## Water Resources Decision Statement for an application for a water abstraction licence at Gore Quarry, Walton, Presteigne, Powys.

**Application number:** PAN-023639

**Licence number:** WA/055/0008/0006

Map 1

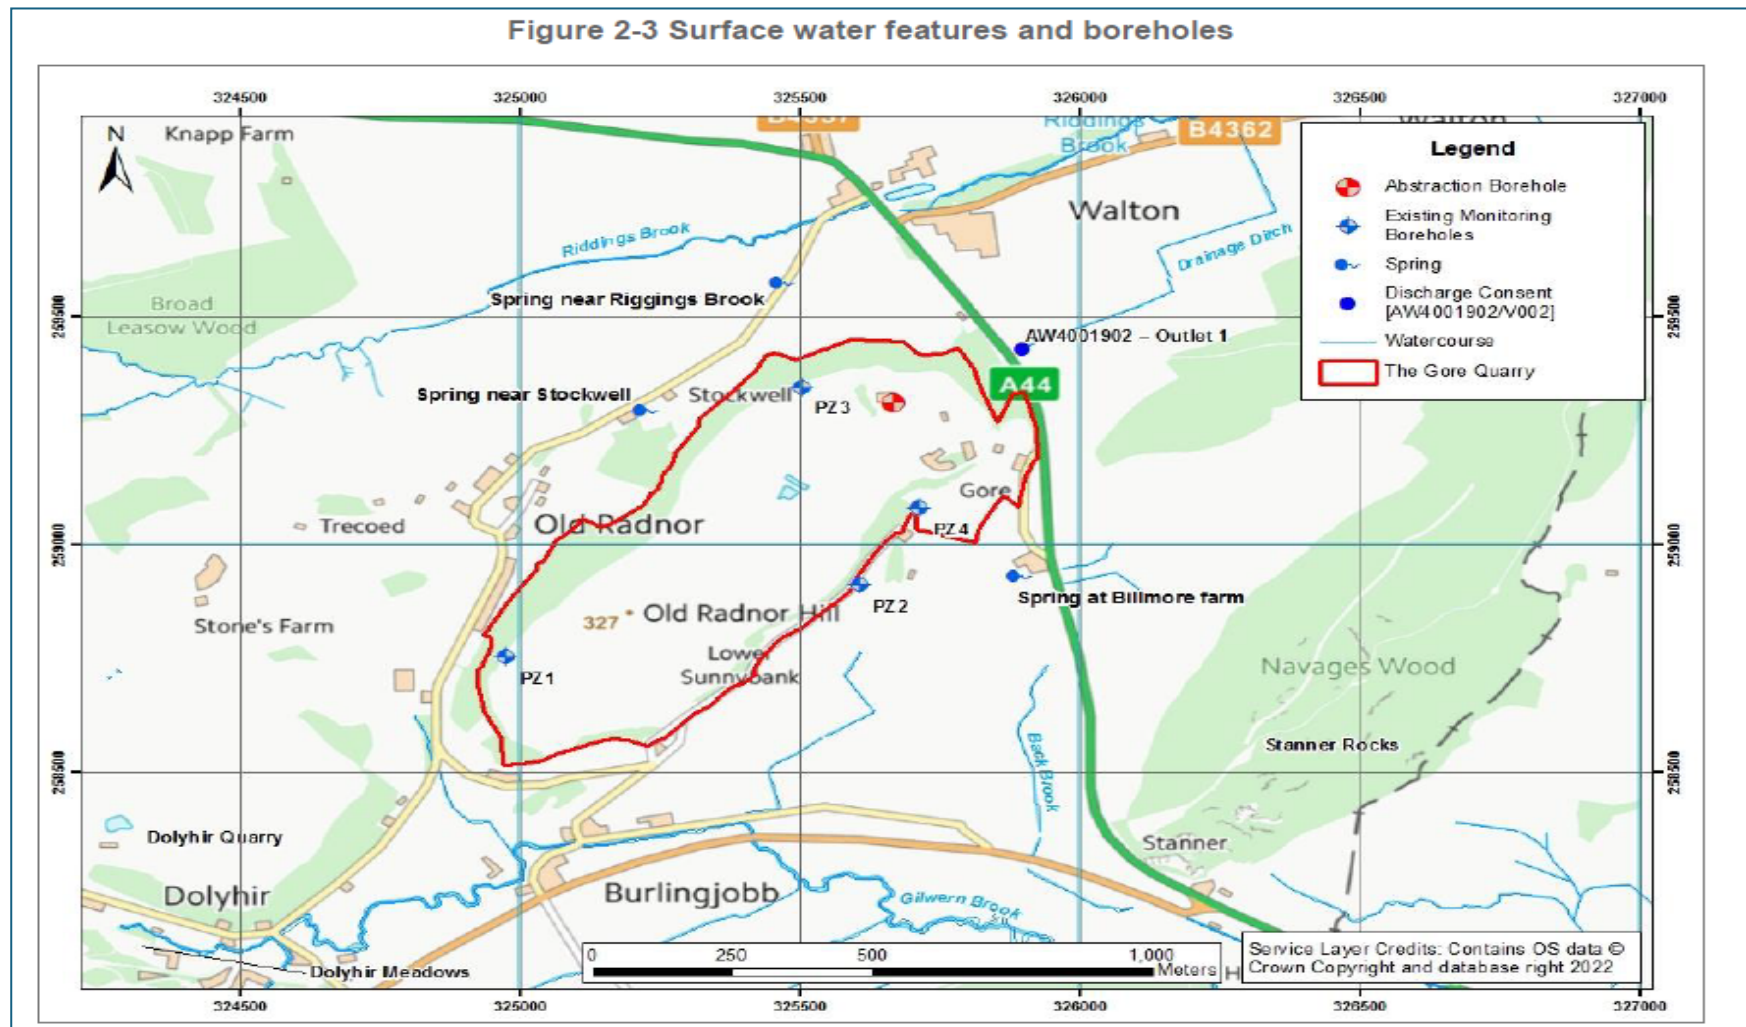
Four piezometers (also monitoring the Strinds Formation) around the quarry were used for monitoring during the test pump (*see map 1 below*). Non-pumping, the piezometers showed that groundwater levels are higher in the South West corner of the site and reducing in elevation to the North East, implying a groundwater flow direction towards the North East. The springs at Bilmore Farm, Riddings Brook and Stockwell were visually observed during the test pump period. No flow was observed during the testing period. The springs are not used for potable water supply. Therefore, it was concluded that the spring were not at risk of derogation from the abstraction.

Initially the groundwater levels within the abstraction borehole dropped steadily, but after 900 minutes (15 hours) the groundwater levels dropped and the resultant time vs. drawdown graph showed a steep drop. This steepening of the graph indicates a low permeability (or no flow) boundary close to the borehole location, which will limit the yields of the borehole over time. If the abstraction rate is not managed appropriately, the borehole has the potential to dry up and recovery would be slow, as indicated by the recovery test not having reached full recovery in 68 hours.

Only PZ3 showed any noticeable effect from abstraction at the borehole. This is located close the abstraction borehole and to the west. PZ4 is the next closed monitoring location which does show a response to abstraction from the borehole. This indicates that the cone of depression from the abstraction borehole will remain within the confines of the quarry and derogation of local water features and users is limited and unlikely.
